**RE: 7200 Bluewater
Grading and Drainage Plan
Engineer's Stamp Date: 10/08/18
Hydrology File: K10D060**

Based upon the information provided in your submittal received 10/11/2018, the Grading Plan is **not** approved for Building Permit and Site Plan for Building Permit. The following comments need to be addressed for approval of the above referenced project:

C-1

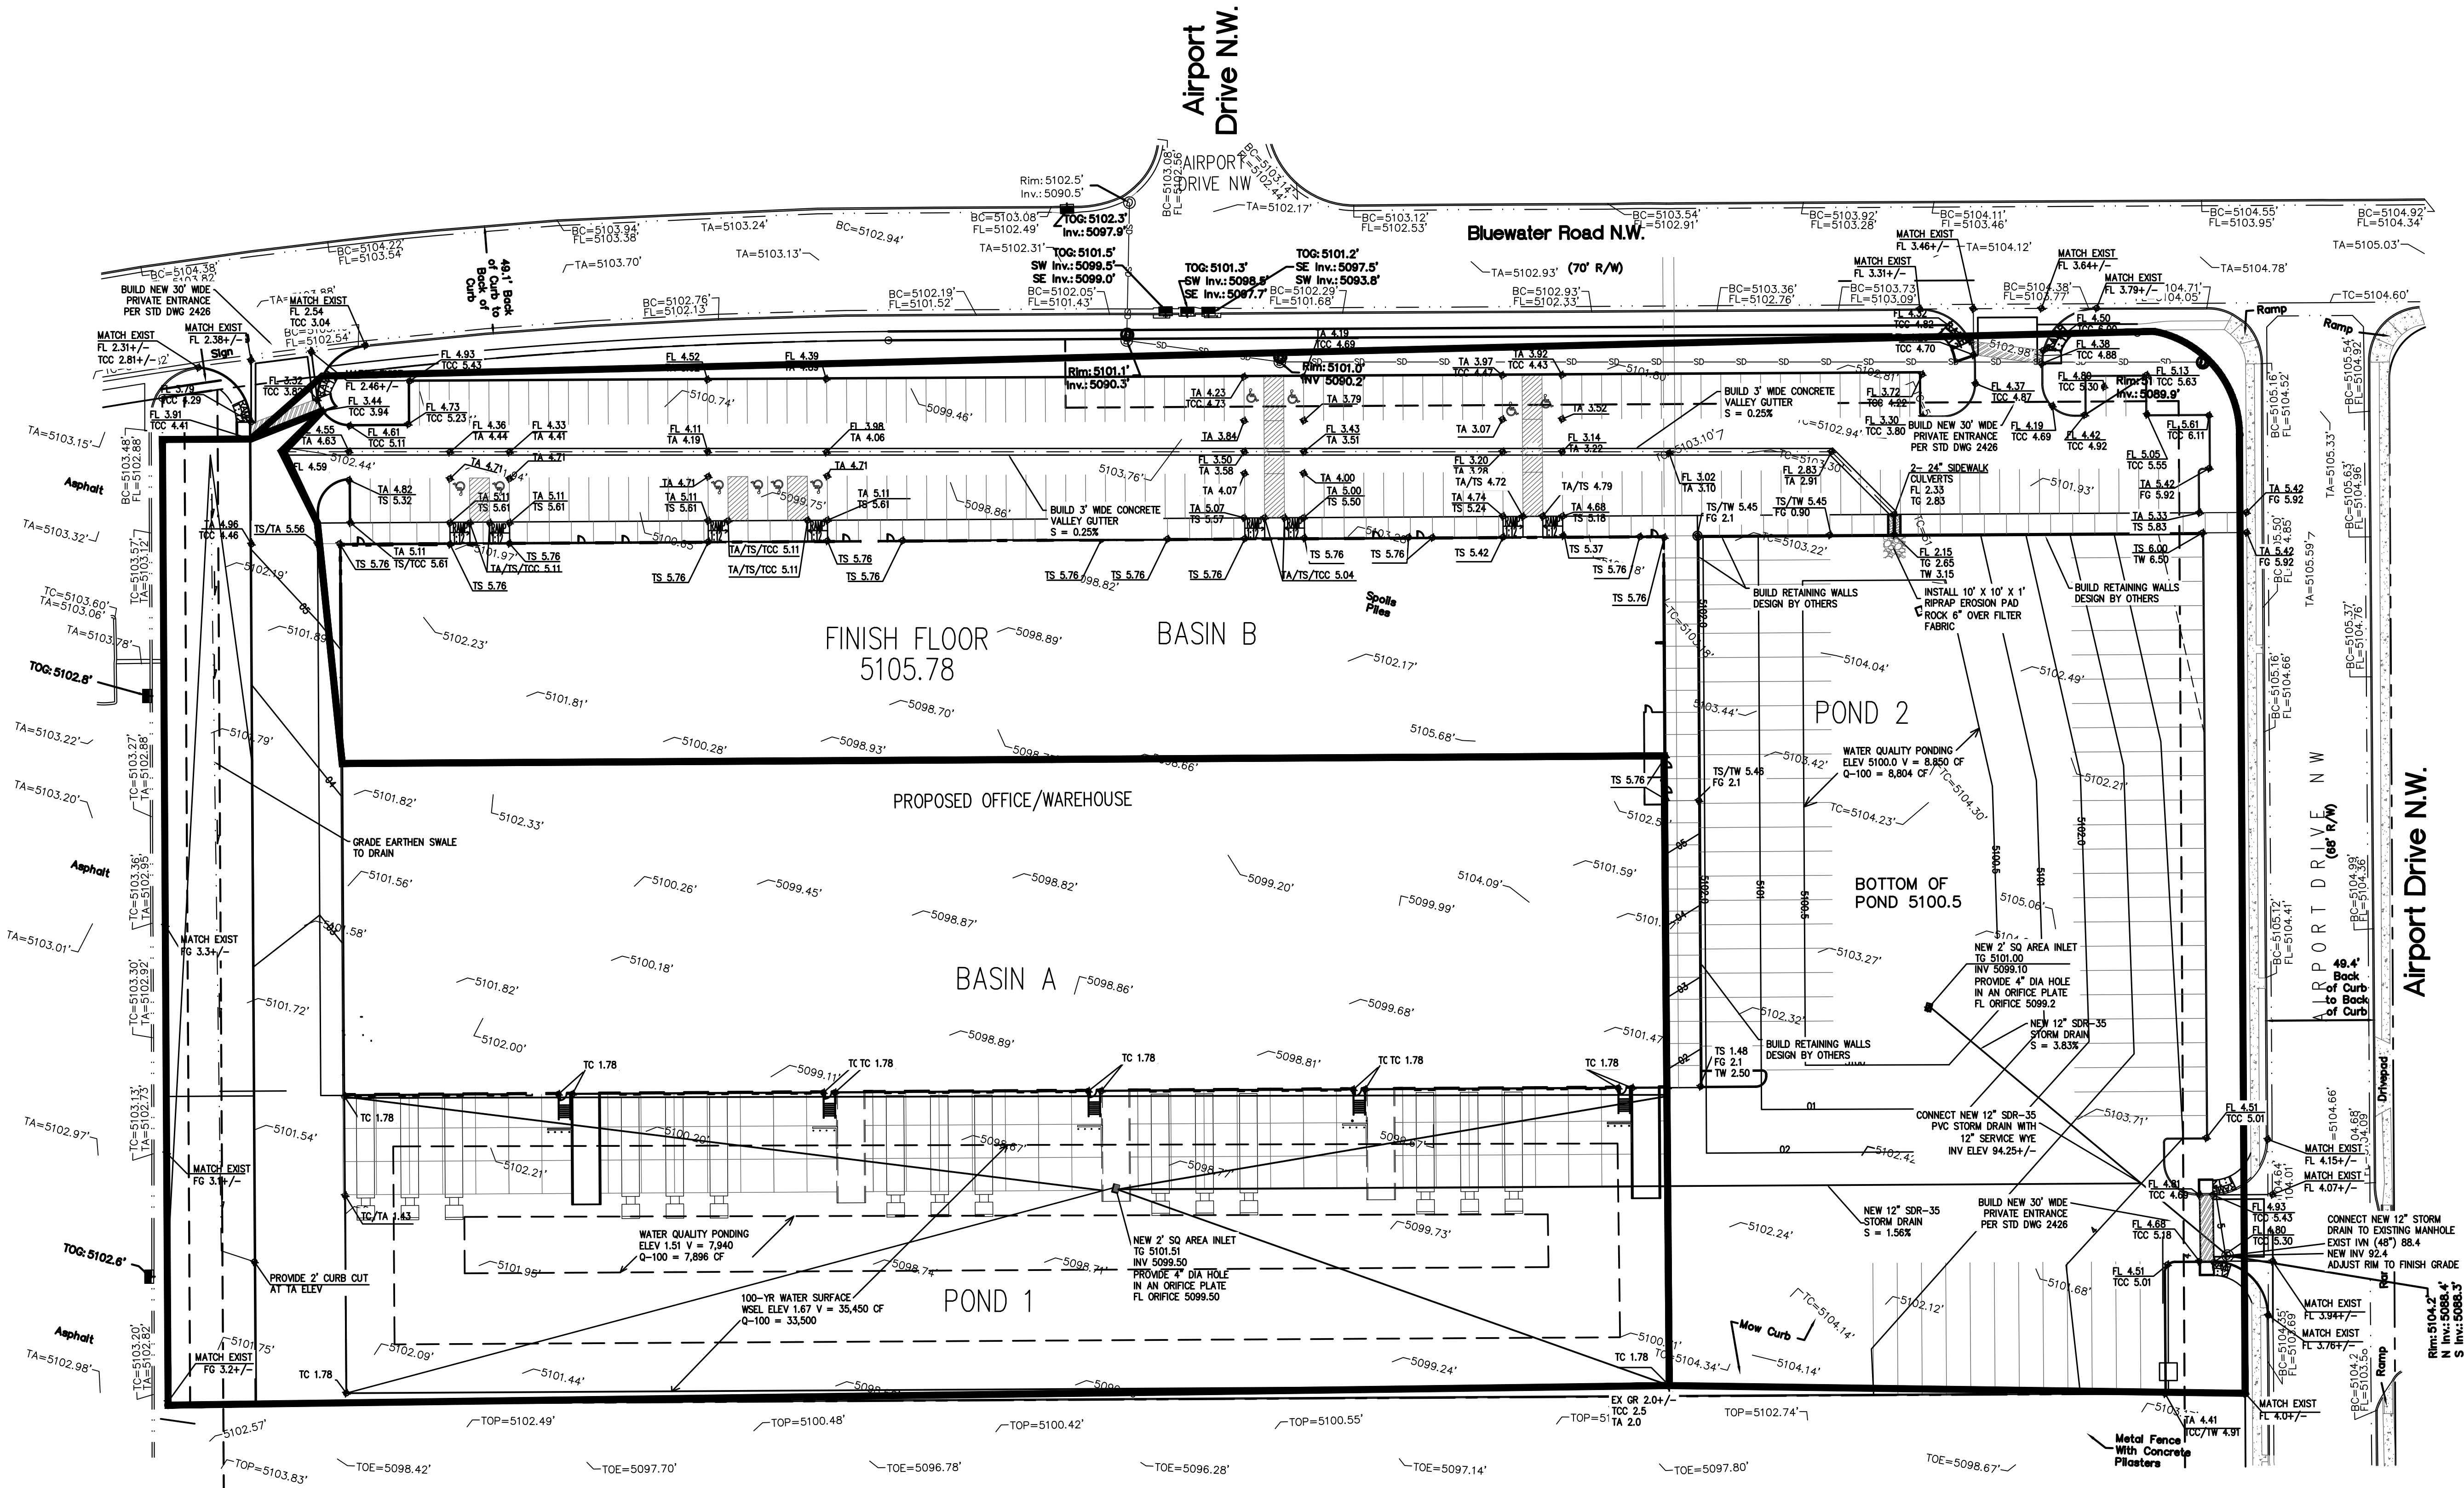
1. Sheet C-1. Please provide the benchmark information for the survey contour information provided.
2. Sheet C-1. Please provide the legal description of the property.

3. Sheet C-1. Please call out the Existing 20' Public Sanitary Sewer Easement along the Northwestern property line.
4. Sheet C-1. The proposed swale can't be placed within the Existing 20' Public Sanitary Sewer Easement. You can ask for a waiver from Albuquerque Bernalillo County Water Utility Authority. If they grant a waiver, then the proposed swale can stay.

5. Sheet C-1. Please add the note of the 100-yr water surface WSEL and the volume provided in Pond 2.
6. Sheet C-1. The First Flush (storm water quality) ponds are typically placed within the landscape area. I noticed that the ponds were located within the asphalt areas. This is not acceptable unless you install a water quality manhole or inlet prior to discharge into the existing storm drain system. Also this can be done with an underground system, which can also handle the detention requirement for the site as well. Another idea is to request a variance of the first flush volume requirement, provide an explanation for this variance, and then pay the Fee in Lieu payment Amount which will be the required volume x \$8/CF. This is all your decision which works best for this project.

C-2

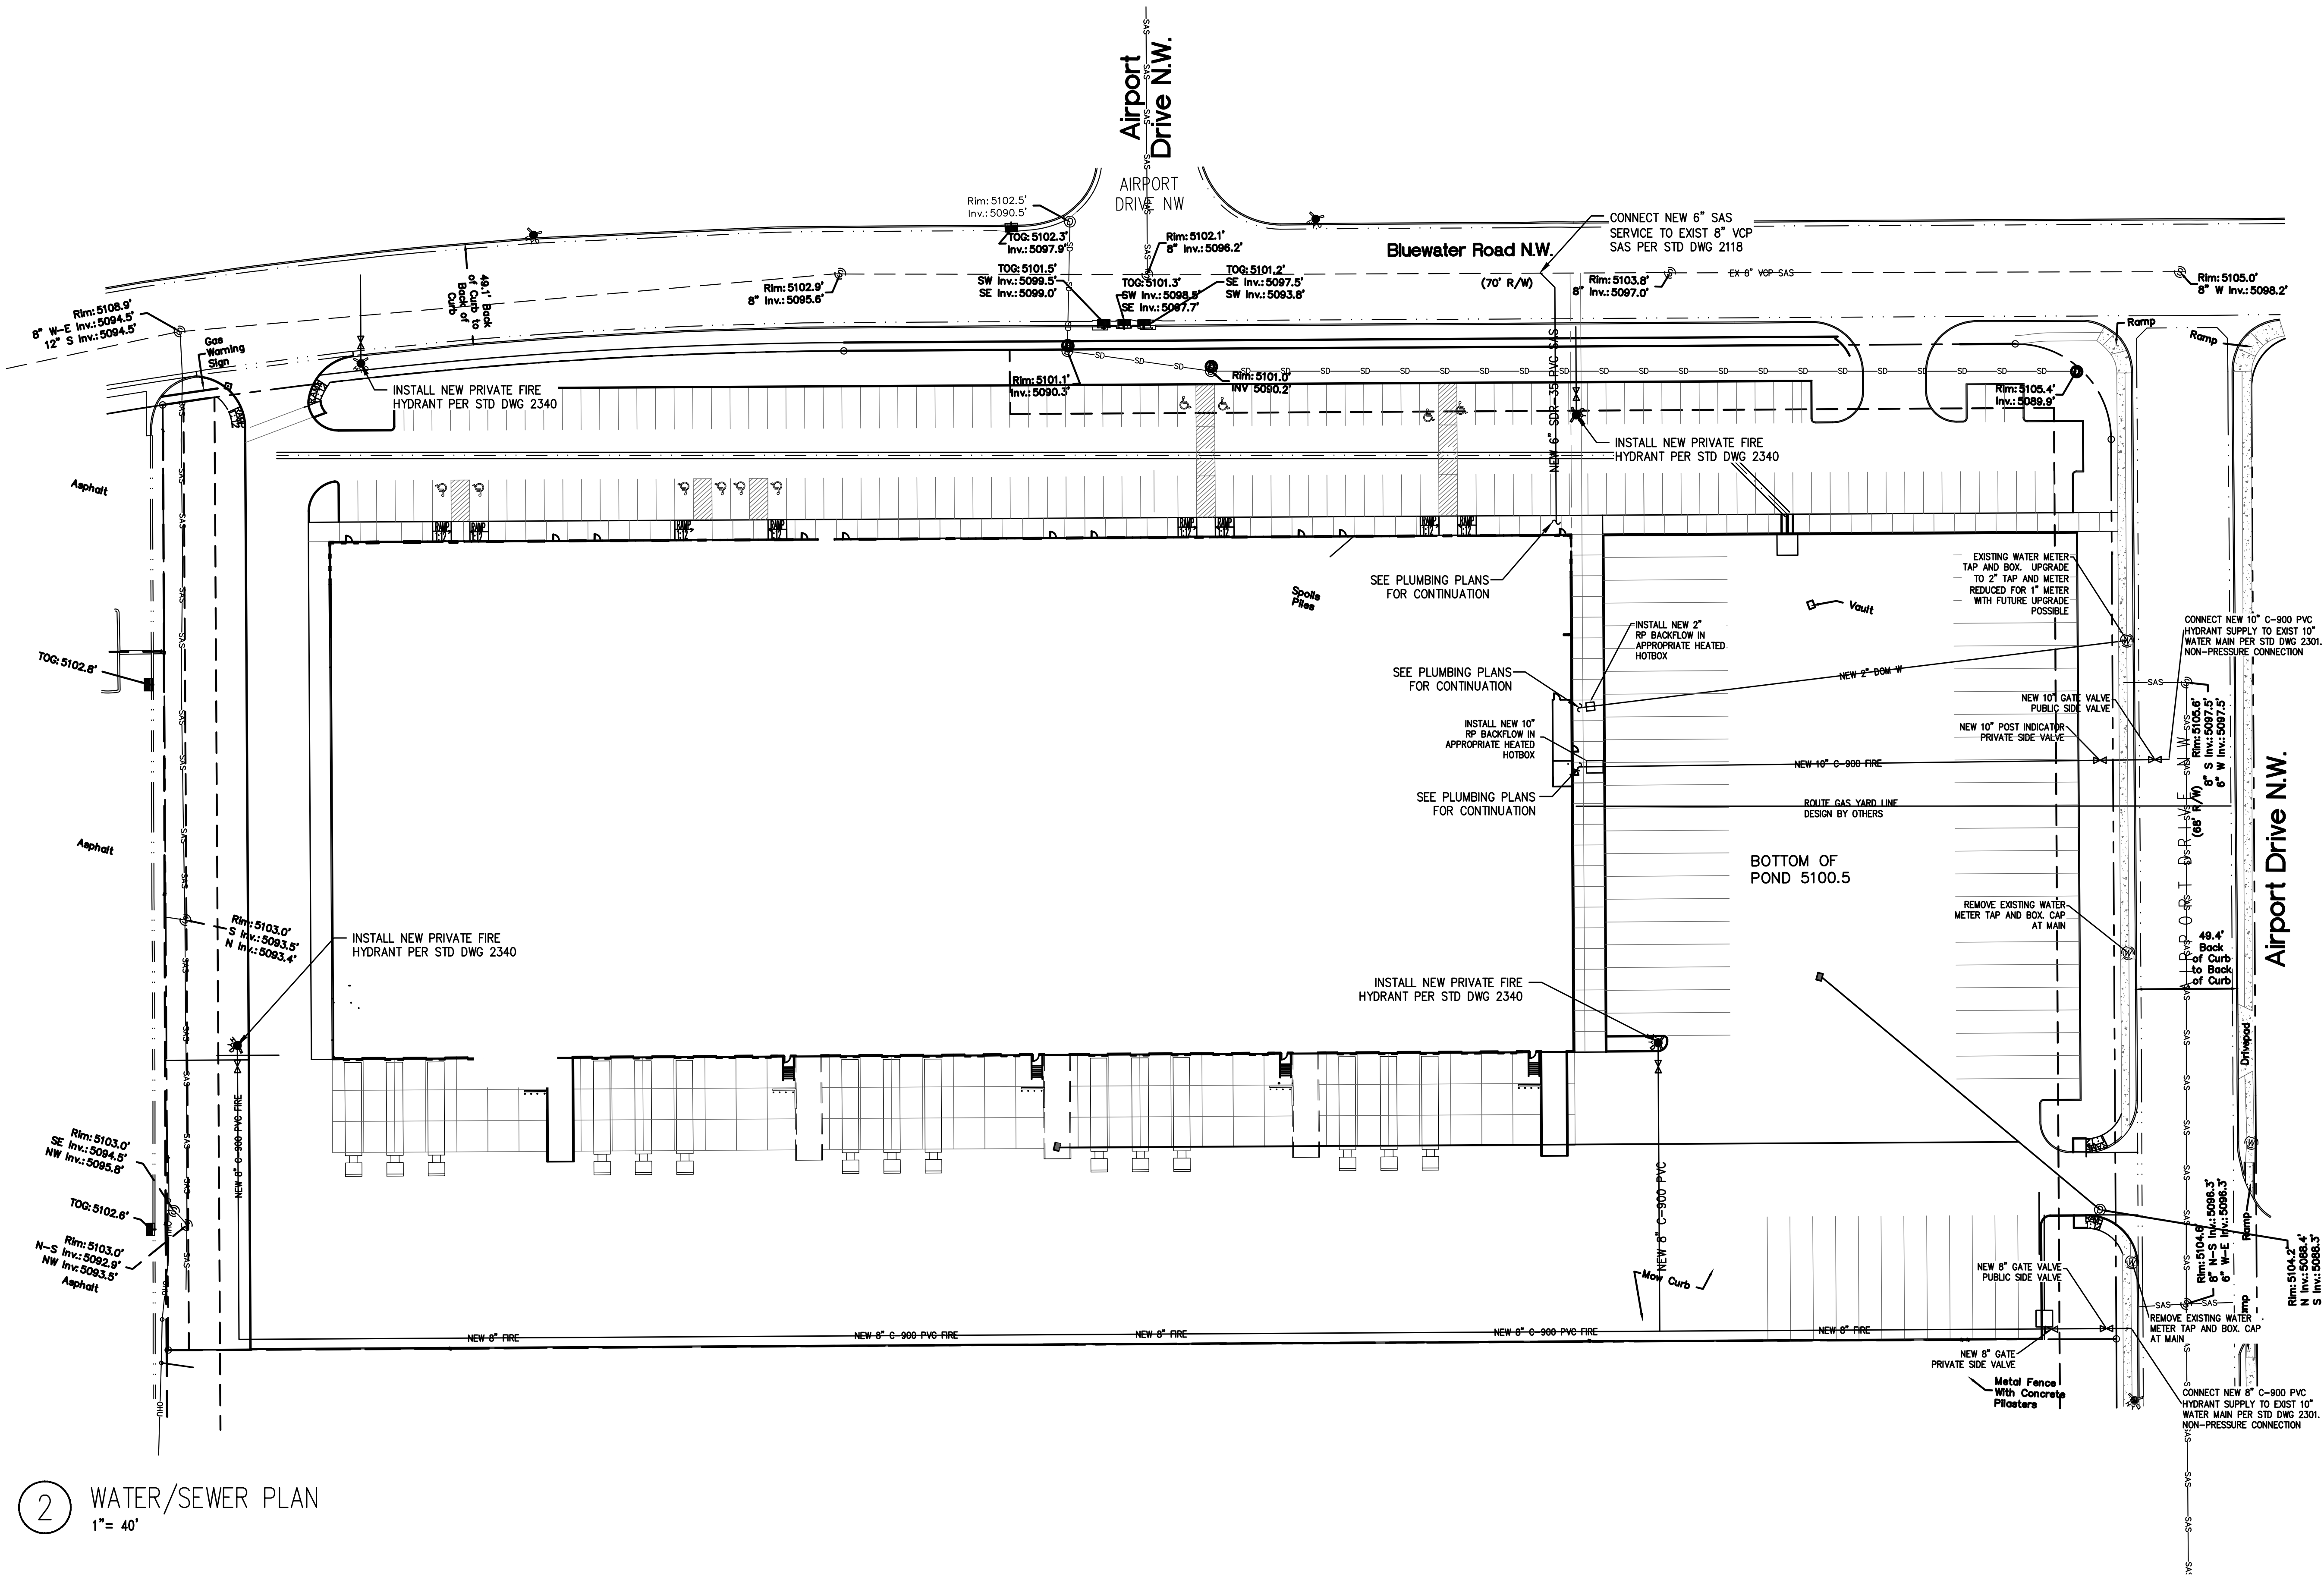
7. Sheet C-2. Please provide the weir calculations for the curb cuts.
8. Sheet C-2. Under Developed Conditions, please insure that the statement includes that the site (10.33 ac) has an allowable discharge of 1.136 cfs and the proposed discharge is 1.08 cfs.
